Access Compliance Report Public Rights-of-Way (Curb Ramps)

Intersection ID: 29706 Main Street: SIMFIELD CHURCH RD **Cross Street: WEDDINGTON RIDGE LN** Location: **ADA ID: DB2ECD4EF358** Ramp Type: Perp Initial Pass/Fail: Fail **Overall Compliance: No** Severity Score: 21.25

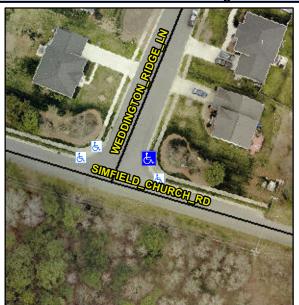
Possible Solutions: Remove & Replace Entire Ramp. Surveyor Notes: N/A PROW/ADA: Not Found, R304.5.1, R304.2.2

Field Measurements/Component Compliance					
Compliance Description Dat		Data	Comp	liance Description	Data
N/A	Ramp Length (in)	49.5	No	Ramp Slope (%)	10.5
No	Ramp Width (in)	36.5	Yes	Ramp XSlope (%)	0.1
N/A	Flare Type LT	N/A	N/A	Flare Type RT	N/A
N/A	Flare Slope LT (%)	N/A	N/A	Flare Slope RT (%)	N/A
N/A	Flare Traversable LT?	N/A	N/A	Flare Traversable RT?	N/A
N/A	Landing Length (in)	N/A	N/A	DWS Provided?	N/A
N/A	Landing Width (in)	N/A	N/A	DWS Contrast?	N/A
N/A	Landing Slope (%)	N/A	N/A	DWS Length (in)	N/A
N/A	Landing X Slope (%)	N/A	N/A	DWS Full Width?	N/A
N/A	Landing Curb? (Y/N)	N/A	N/A	DWS Offset (in)	N/A
N/A	Shared Landing?	N/A			
N/A	Gutter Ponding?	N/A	N/A	Gutter Slope (%)	N/A
N/A	Gutter Lip Ht (in)	N/A	N/A	Gutter X Slope (%)	N/A
N/A	Painted X Walk1?	No	N/A	Painted X Walk2?	N/A
	X Walk 1 Direction	To NE		X Walk 2 Direction	N/A
N/A	X Walk 1 Width (in)	N/A	N/A	X Walk 2 Width (in)	N/A
	X Walk 1 Slope (%)	4.2		X Walk 2 Slope (%)	N/A
